DRAFT ENVIRONMENTAL IMPACT REPORT FOR VALLEY'S EDGE SPECIFIC PLAN
– DATED OCTOBER 2021 (STATE CLEARINGHOUSE NUMBER: 2019089041)

RE: Review of the Valley's Edge Specific Plan Draft EIR

RE: Draft Environmental Impact Report - Valley's Edge Specific Plan

RE: VALLEY'S EDGE SPECIFIC PLAN (PROJECT)(VESP)
DRAFT ENVIRONMENTAL IMPACT REPORT (DEIR) SCH#2019089041

Exhibit: Proposed
Detention (R5R6)
December 13, 2021

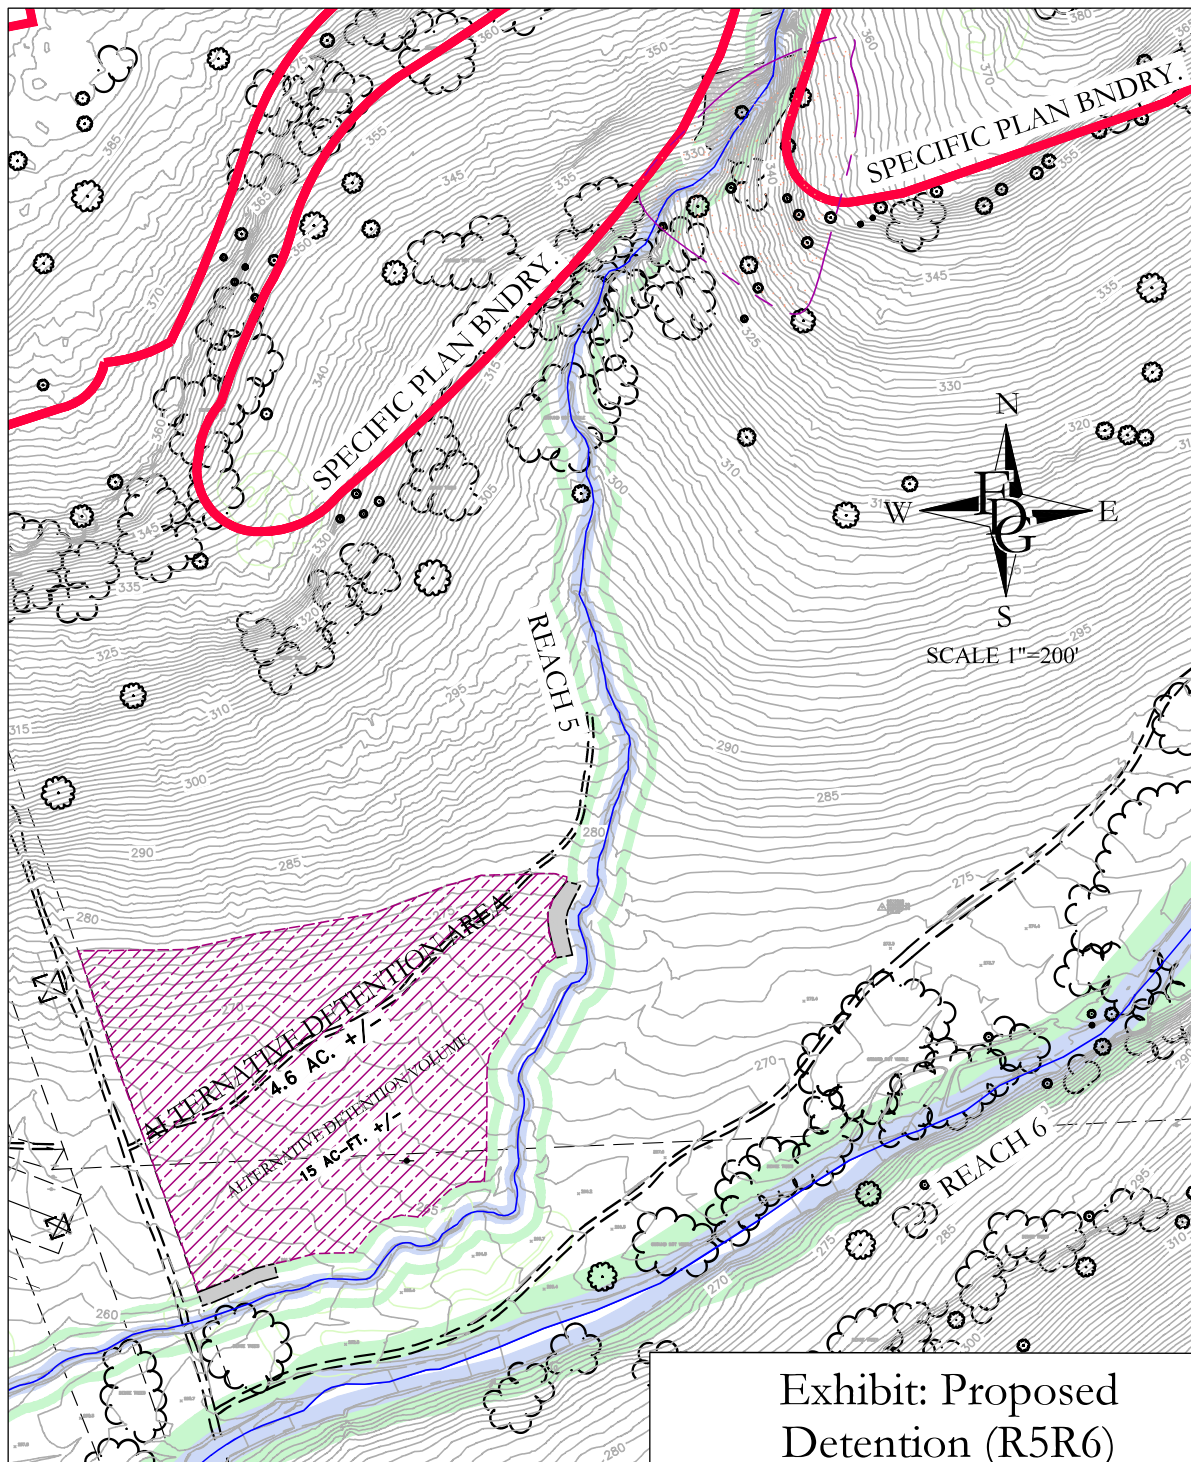
1) On Figure 4.9-3 – Proposed Reach R5 Detention Basin; we recommend that the alternative detention volume be changed from 10 ac-ft to 15 ac-ft. This is based on "Drainage Report Addendum #1," which was prepared by Frayji Design Group on September 14, 2021 and provided to the City. This report has been amended as of 12/13/2021 to rectify any unclear language regarding development area within reach 6. (attached hereto)
